YARRA CITY COUNCIL

Internal Development Approvals Committee

1.1 21 King Street, Richmond - PLN13/0545 - Development of the land for demolition of the existing dwelling and construction of two, double-storey dwellings, including roof terraces and a reduction in the car parking requirement.

1.2 Heritage Victoria Referral (P15249) - Dimmeys, 140-160 Swan Street, Cremorne

Attachment 2 - PPE14/0213 - 140-160 Swan Street Cremorne - h2184 Heritage Victoria referral plans

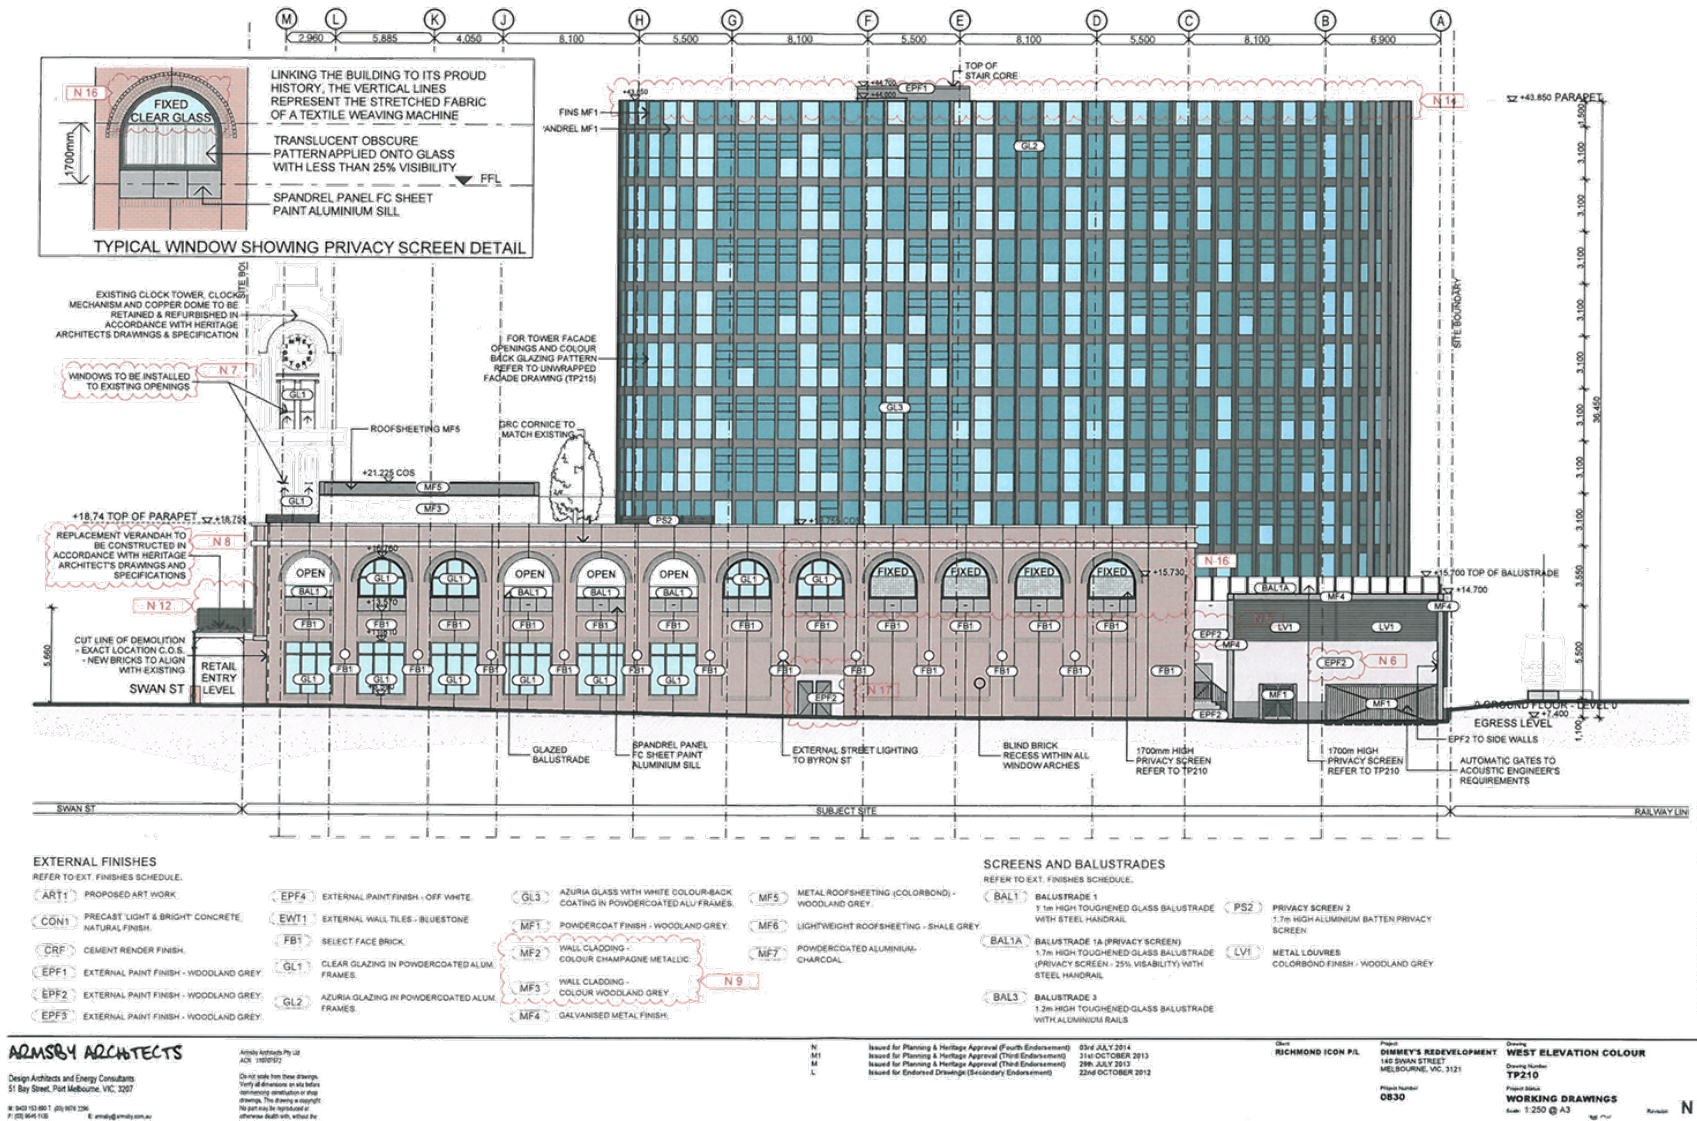
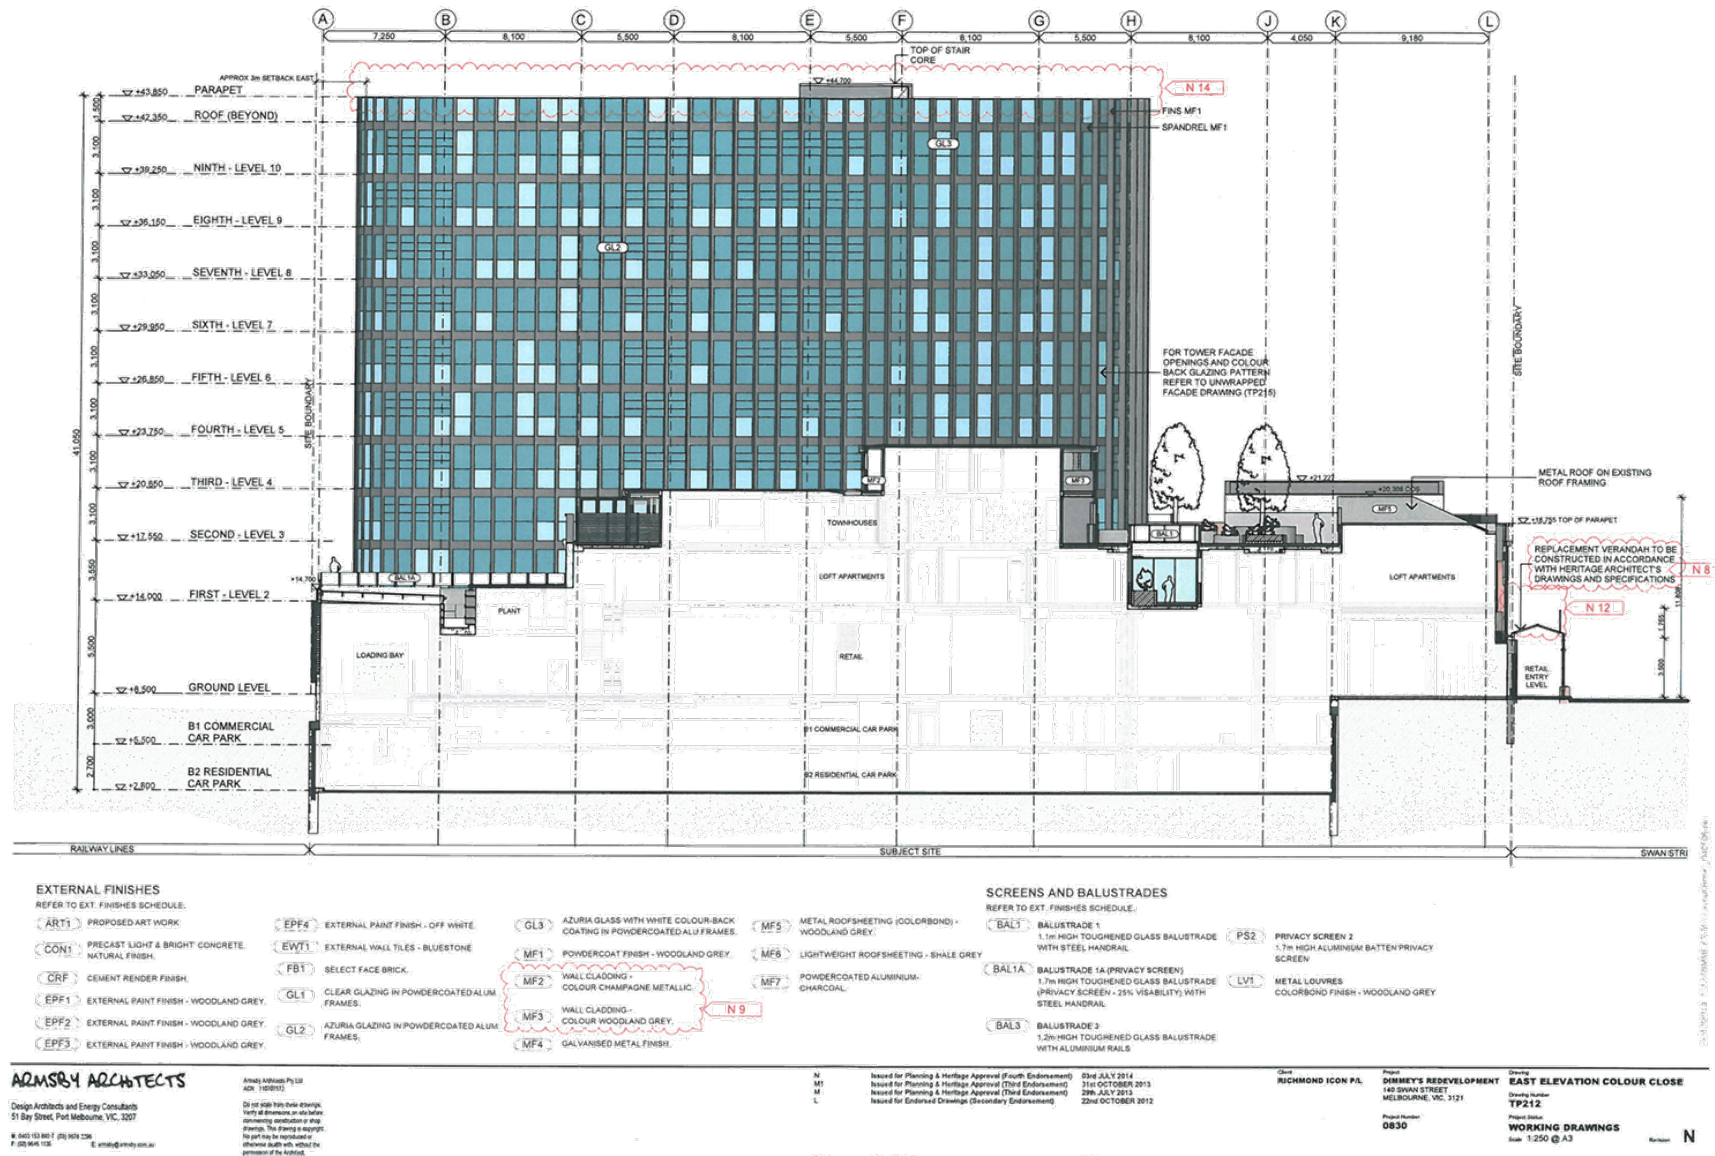
- (a) N13 – Change to the Green Street light fittings. Contemporary fittings are proposed in place of a faux historic form.
 - (b) N14 – Deletion of roof top plant screening.

4. The application to Heritage Victoria seeks the following amendments:
 - (a) N13 – This change relates to the light fittings to the east (Green Street) elevation. The previous plans indicated refurbishment and reinstatement of the existing external light fittings. The applicant has stated that these were not original and have been found to not be suitable for refurbishment. It is now proposed to use contemporary fittings in place of a faux historic form. The fittings have an extension arm of approximately 400mm beyond the fitting size of 155mm x 208mm x 220mm. The fittings will illuminate the bottom area of the elevation, including the mural and footpath and will be provided in five locations.

- (b) N14 – This change involves the deletion of roof top plant screening. Detailed design has revealed that none of the rooftop plant is higher than the façade balustrade. The currently approved screen extension above the façade is therefore redundant.

- (d) N16 – The glazing to the west of the level 2 terraces in the Dimmeys building, facing Byron Street, has been reviewed and it is proposed to provide clear glazing to 4 arched openings above existing 1.7m high obscured glass balustrades to lofts 2.03 (1 arch) and 2.04 (3 arches). This is to meet acoustic requirements for these dwellings and full height glazing is already approved for four of the other eight arches along Byron Street.

- (e) N17 – The double egress door in the alcove mid-way along Byron Street was proposed to be metal clad and is now proposed to be a painted finish matching the car park entry walls to the south. This is a non-original area of the Dimmeys building and an area where change has already been approved.
- 5. The proposed amendments are detailed in plans submitted and provided by the permit applicant.

15. Council's Heritage Advisor has reviewed the proposed works (associated with the Heritage Victoria amendment application) and commented that the proposed alterations to the previously approved works would be generally in accordance with the requirements of Yarra's heritage policy at Clause 22.02-5.7.1 of the Yarra Planning Scheme.
16. The only recommendation is that if the existing light fittings along the east (Green Street) elevation cannot be restored, then new fittings that enhance the character of the building should rather be considered compared to the contemporary fittings proposed.

1. That Council advise Heritage Victoria the following with regard to the proposal:
 - (a) The proposed alterations to the previously approved works would be generally in accordance with the requirements of Yarra's heritage policy at Clause 22.02-5.7.1 of the Yarra Planning Scheme.
 - (b) In regard to the proposed light fittings along Green Street, it is acknowledged that while the existing fittings may not be original they definitely have a particular style that enhances the heritage character and appearance of the subject building. The proposed contemporary fittings will not replicate this quality. If the existing fittings cannot be restored, then new fittings that enhance the character of the building should rather be considered.
